DESIGN SCENE

OFFICE OF PROJECT MANAGEMENT & TECHNICAL SUPPORT

PROJECT DESIGN SERVICES UNIT

December 2017 - Page 1

Chapter 16 – ONE DIRECTION LARGE ARROW

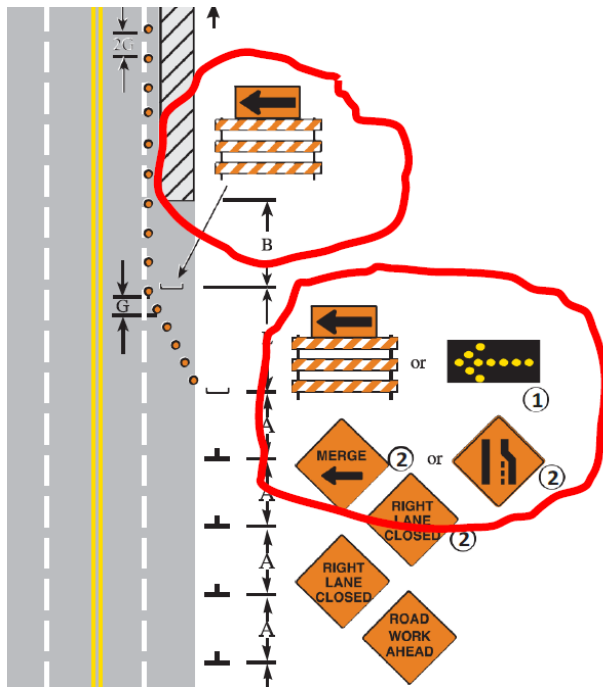
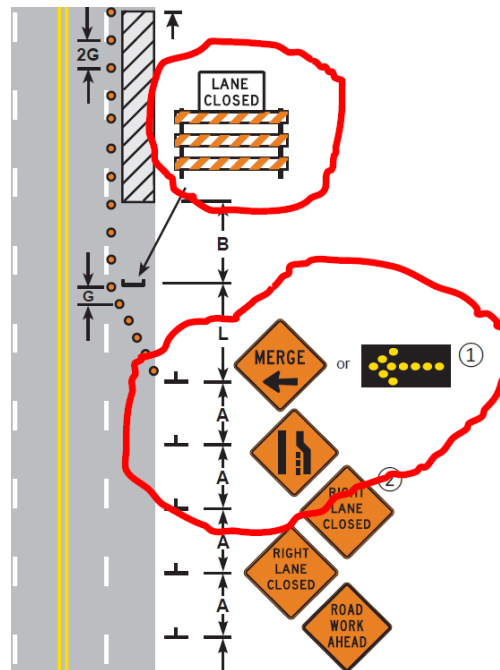
MUTCD that allowed this use. The One-Direction Large Arrow is governed by language in Warning Signs Chapter 2C (2C.12) that limits its use to delineating a change in horizontal alignment for curves. Language was drafted for consideration by the Minnesota Committee on Uniform Traffic Control Devices, but it was found to not be in compliance with the Federal MUTCD.

Per a recent clarification from the FHWA, it cannot be used for merging tapers, though it will still be used for shifting tapers. **Therefore, for all projects submitted for the January 26, 2018 letting or later must following the new layout as described below.**

Due to this clarification, the Field Manual Committee has developed new layout, instead of the One Direction Large Arrow on the Type III barricade at the end of the taper, a LANE CLOSED (black on White) sign will be used (required when speed limit is 45 mph or greater). If the Flashing Arrow Board is not used (it is required when speed limit is 45 mph or greater), a MERGE with Arrow sign will be placed at the beginning of the taper.

PREVIOUS METHOD-
NO LONGER ALLOWED

NEW METHOD
